PG&E Letter DCL-00-041

Docket No. 50-275, OL-DPR-80
Docket No. 50-323, OL-DPR-82
Diablo Canyon Units 1 and 2
License Amendment Request 00-01,
Administrative Revisions to the Improved Technical Specifications

ADMINISTRATIVE REVISIONS TO THE IMPROVED TECHNICAL SPECIFICATIONS

EXAMPLE 1.2-2

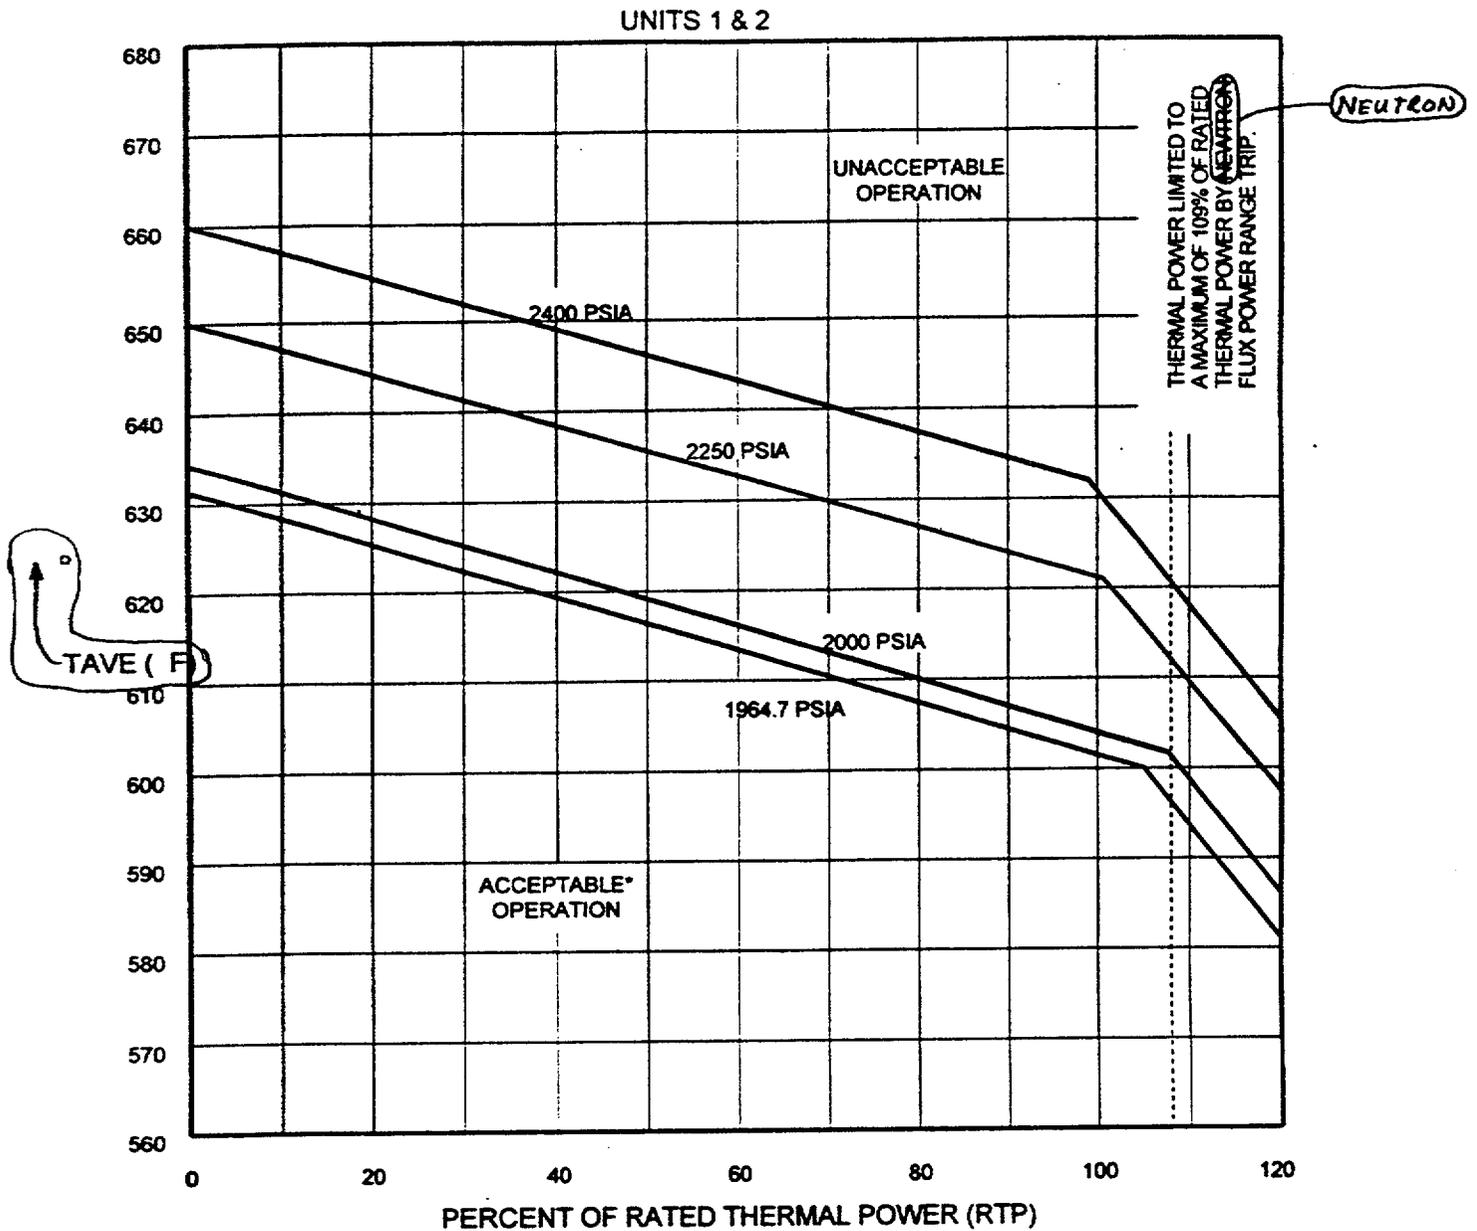
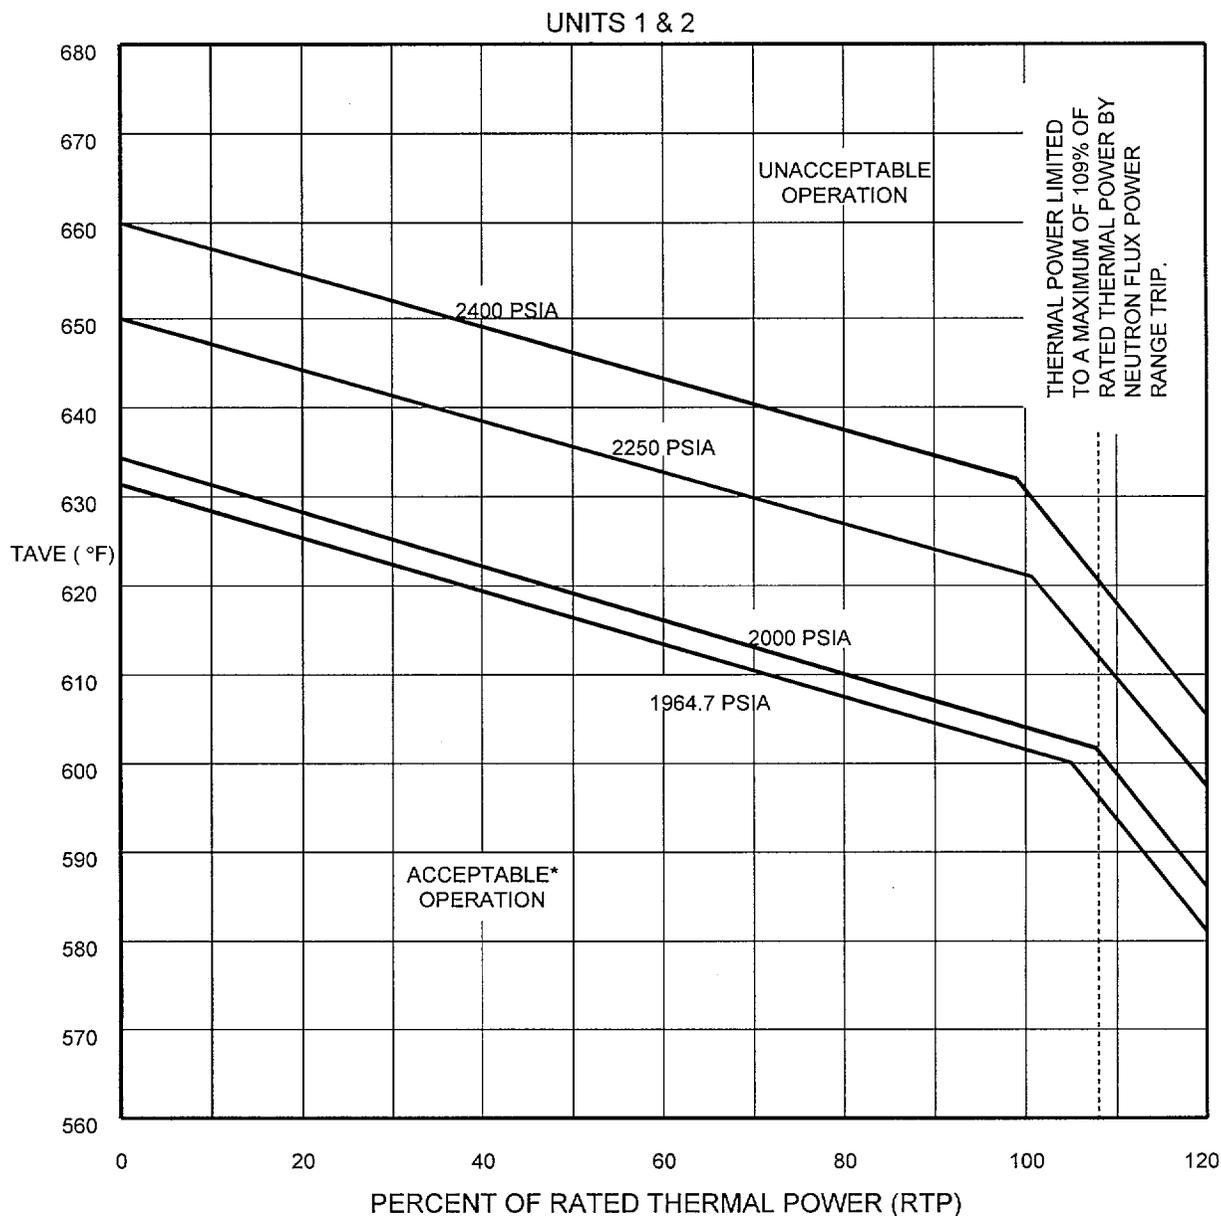
- a. Technical Specification (TS) 1.2, Example 1.2-2, Required Action A.2 - Correct the misalignment of the logical connector.
 - b. TS 2.1, Figure 2.1.1-1 - Correct spelling error and text misalignment.
